NEW ELEMENTARY AND MIDDLE SCHOOL

CONTENTS - VOLUME TWO

phase	Bid Package No. 2
date	January 3, 2008
ADD	October 17, 2007
ADD	October 26, 2007
ADD	November 2, 2007
ADD	November 5, 2007

project # 06022

Lighting Plan
Sector "H"

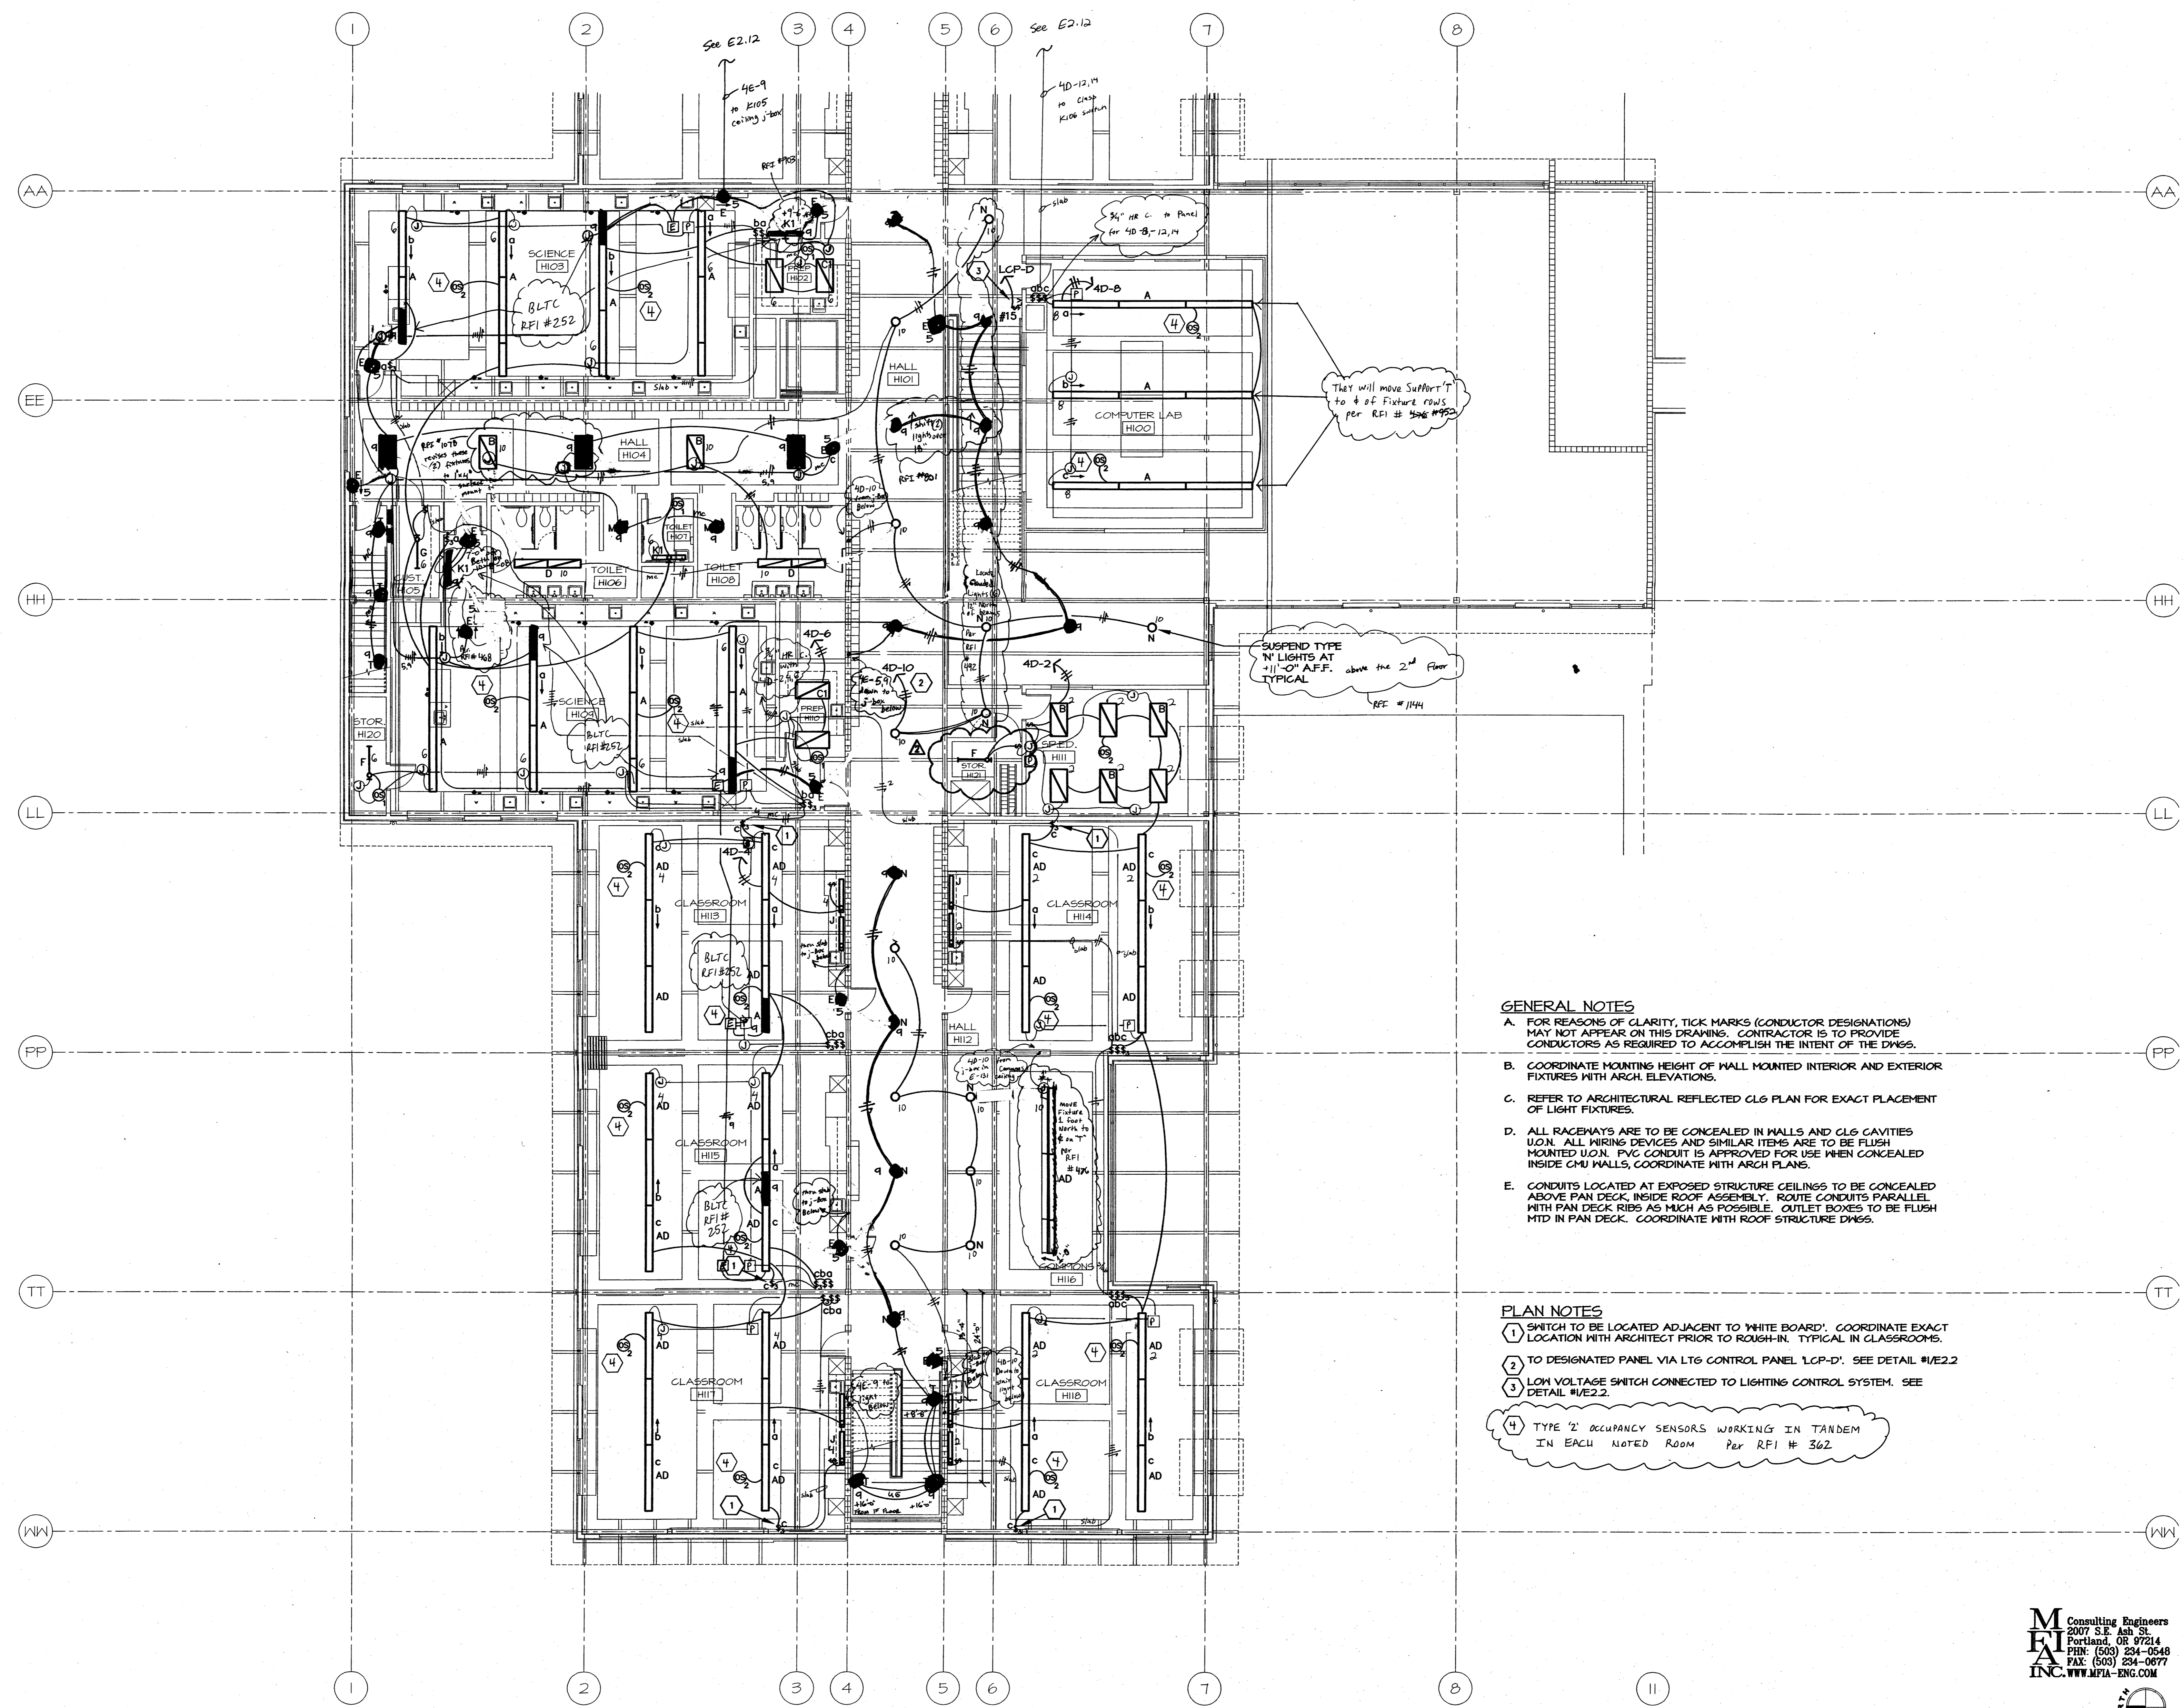
- PLAN NOTES**
- 1 SWITCH TO BE LOCATED ADJACENT TO 'WHITE BOARD'. COORDINATE EXACT LOCATION WITH ARCHITECT PRIOR TO ROUGH-IN. TYPICAL IN CLASSROOMS.
 - 2 TO DESIGNATED PANEL VIA LTG CONTROL PANEL 'LCP-D'. SEE DETAIL #E2.2
 - 3 LOW VOLTAGE SWITCH CONNECTED TO LIGHTING CONTROL SYSTEM. SEE DETAIL #E2.2
 - 4 TYPE '2' OCCUPANCY SENSORS WORKING IN TANDEM IN EACH NOTED ROOM Per RFI # 362

Lighting Plan
Sector "J"

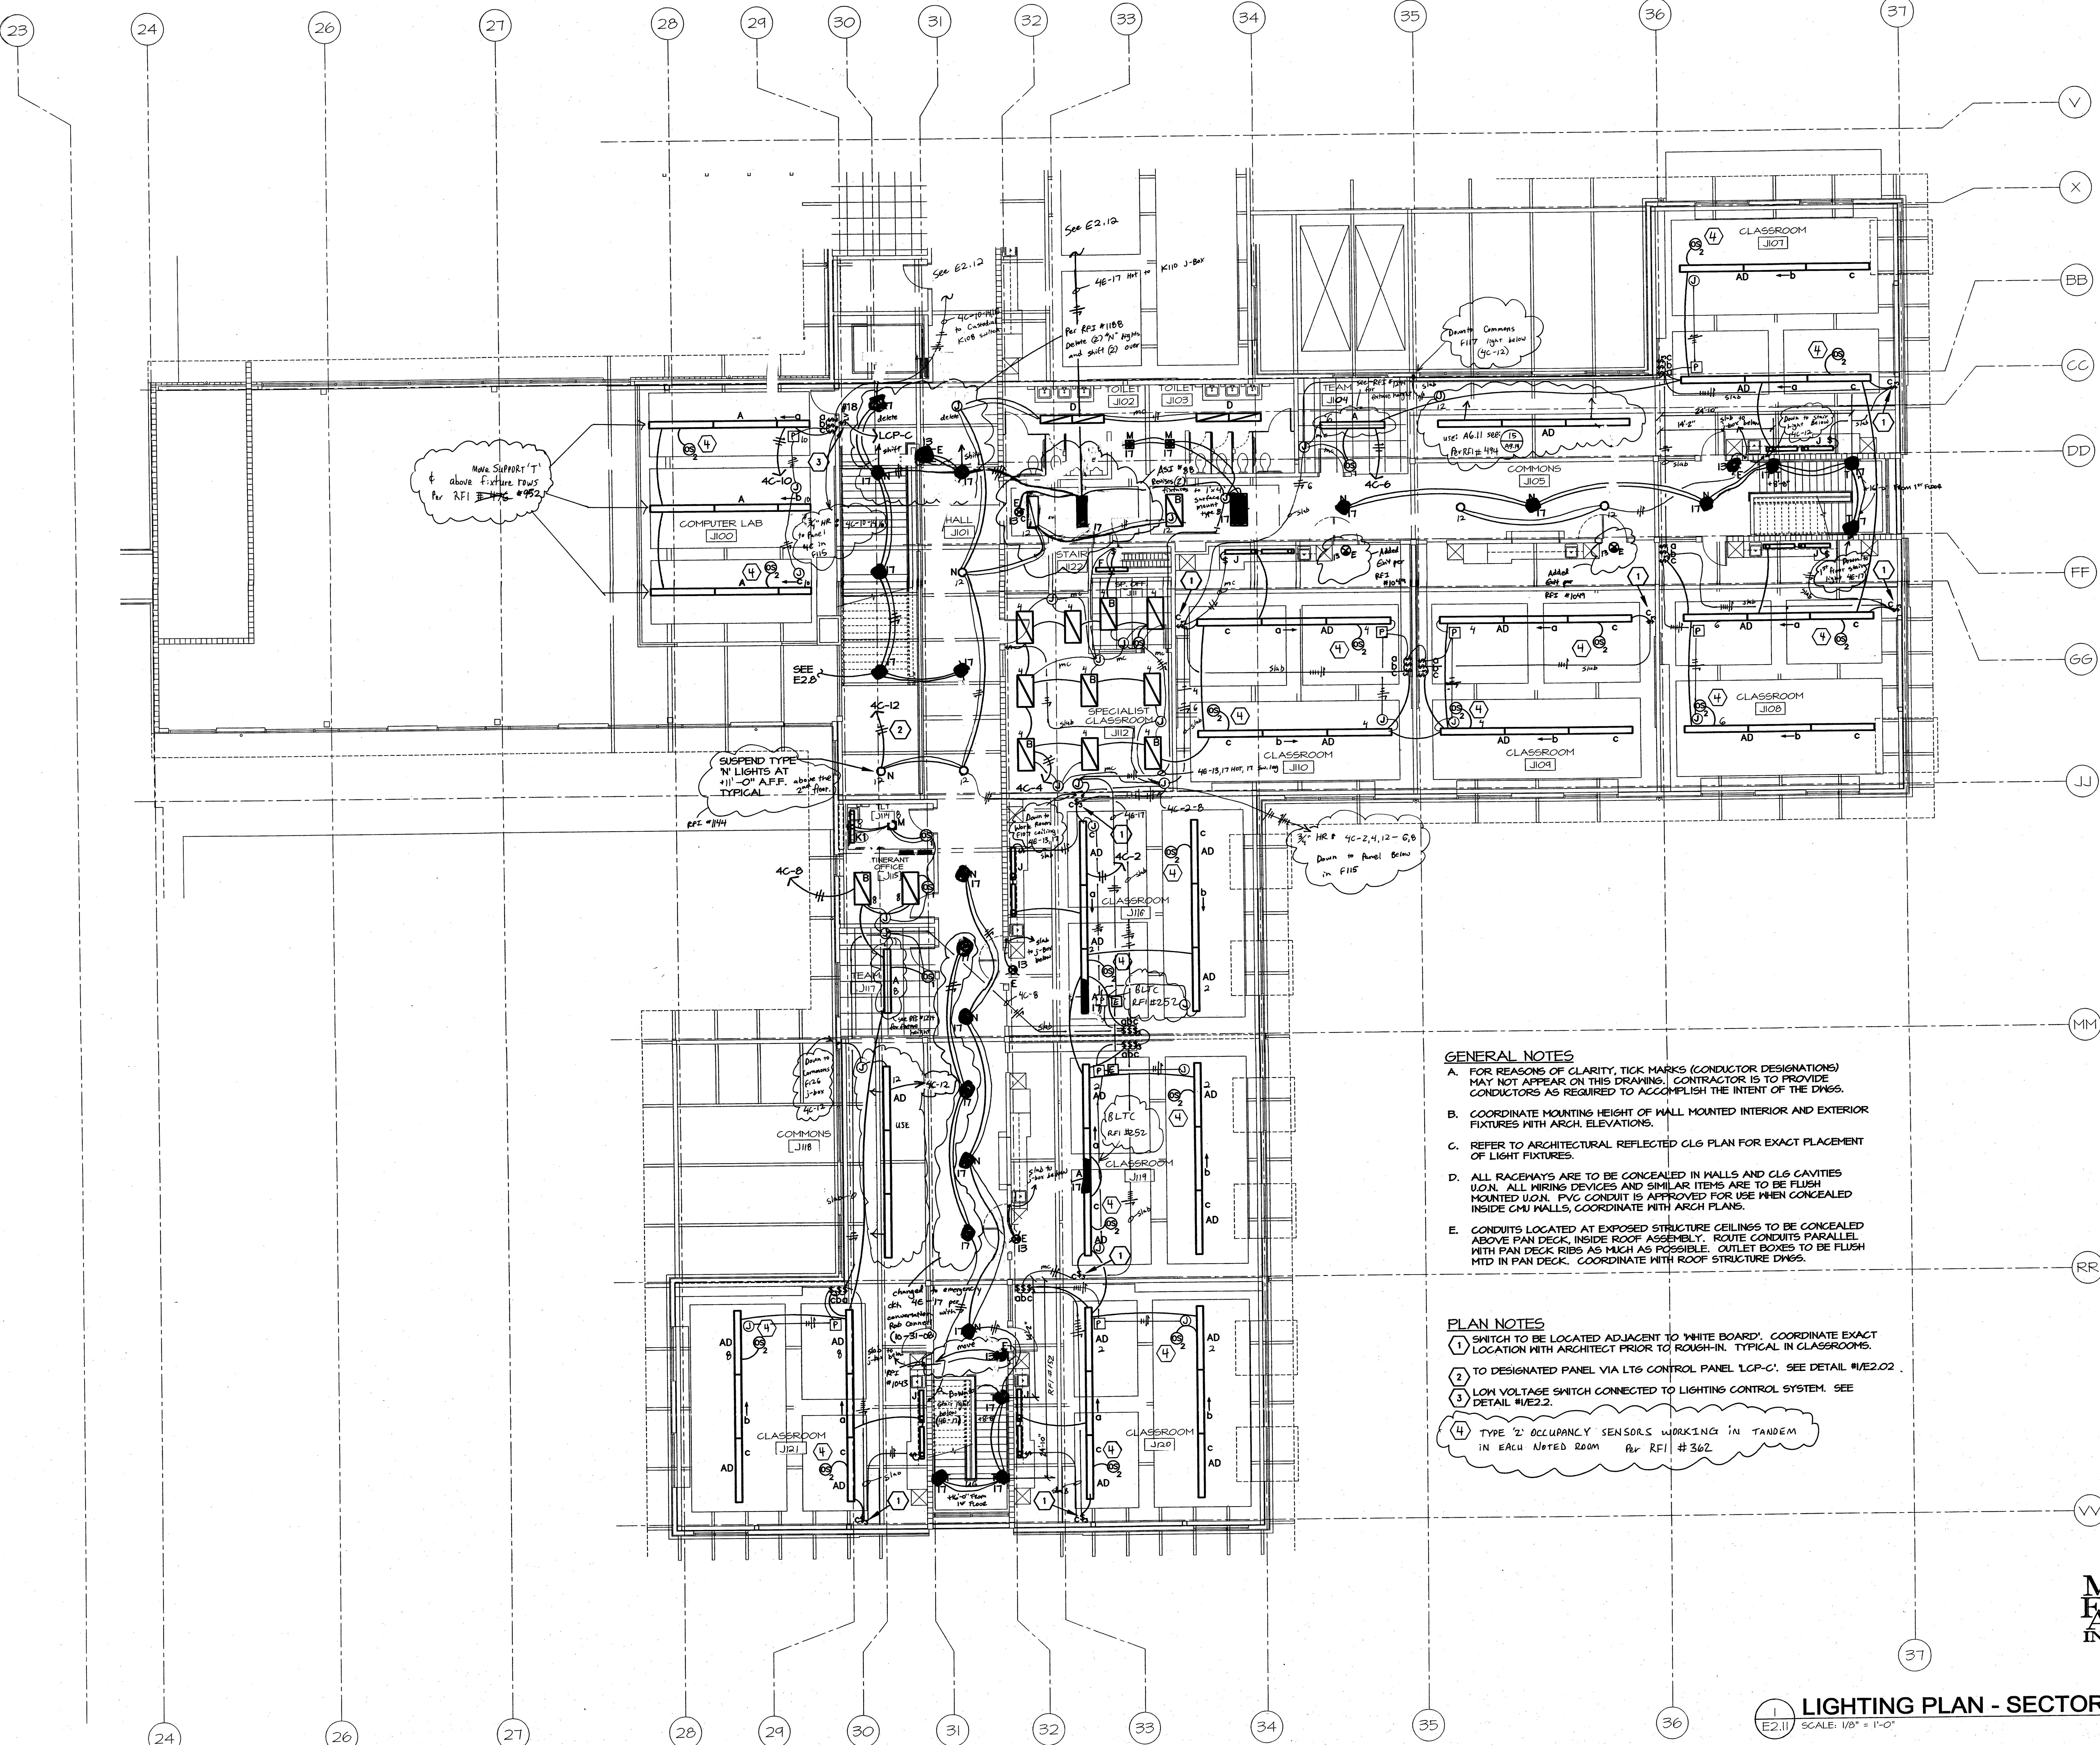
- 1 SWITCH TO BE LOCATED ADJACENT TO 'WHITE BOARD'. COORDINATE EXACT LOCATION WITH ARCHITECT PRIOR TO ROUGH-IN. TYPICAL IN CLASSROOMS.
- 2 TO DESIGNATED PANEL VIA LTG CONTROL PANEL LCP-C. SEE DETAIL #1/E2.02
- 3 LOW VOLTAGE SWITCH CONNECTED TO LIGHTING CONTROL SYSTEM. SEE DETAIL #1/E2.2.
- 4 TYPE "2" OCCUPANCY SENSORS WORKING IN TANDEM IN EACH NOTED ROOM PER RFI # 362.
